Wisconsin Department of Transportation

Proposal #30: 1570-00-74, WISC 2020 101
St. Croix Falls – Turtle Lake
STH 46 South Junction to Front Ave
USH 8
Polk County

This is Addendum No. 01, which provides for the following:

Addendum No. 01
ID 1570-00-74/77
Revised Sheet 3
February 26, 2020

SHEET 3

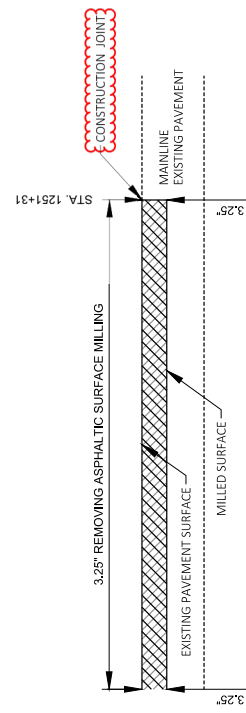
Revised Plan Sheets	
Plan Sheet	Plan Sheet Title (brief description of changes to sheet)
3	The general note, line 16 <i>“Ramps shall be paved when the difference between existing surface and milled surface is greater than 2” and is incidental to paving</i> ” has been removed from the sheet.
19	The third note on this sheet stating that asphaltic surface patching required for temporary butt joint ramps or wedges will be paid for separately has been removed from the sheet and replaced with: <i>“Ramps shall be paved when the difference between existing surface and milled surface is greater than 2”. Installation and removal of temporary ramps or wedges are incidental to removing asphaltic surface milling. No quantity deduction shall be made for the HMA material used for temporary ramps or wedges during mainline paving.”</i> Minor edits to construction detail titles and annotation were also made.
